# CITY OF TAMPA

## ADDENDUM 3

**DATE: September 13, 2017**

Contract 17-C-00011; Howard F. Curren AWTP Final Sedimentation Tanks Air Piping Improvements

HOWARD F. CURREN AWTP FINAL SEDIMENTATION  
TANKS AIR PIPING IMPROVEMENTS  
MISCELLANEOUS DETAILS (1)

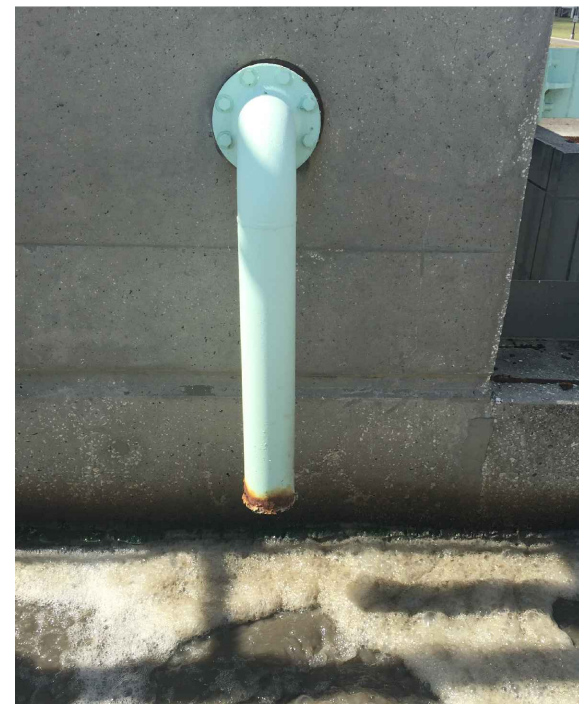
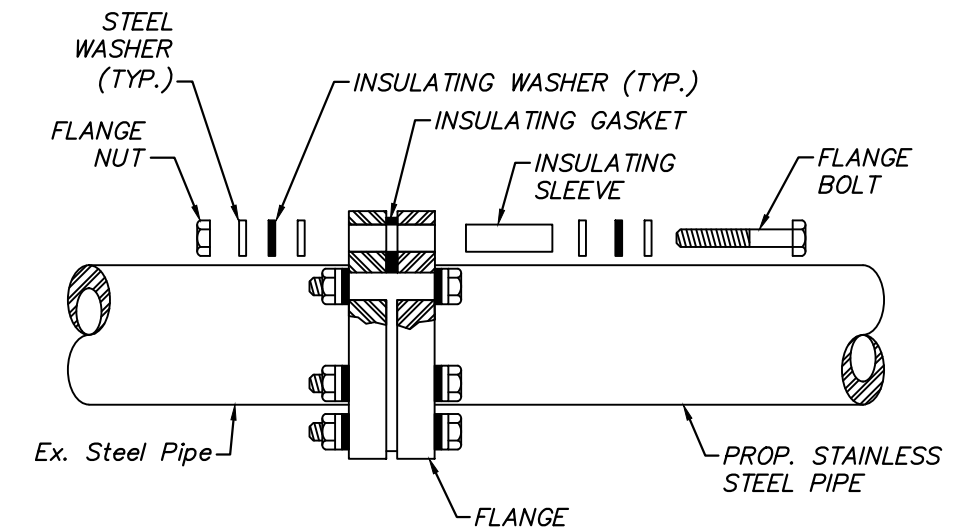
NOTE: USE AN INSULATING FLANGE BETWEEN EXISTING PIPE AND NEW STAINLESS STEEL PIPE
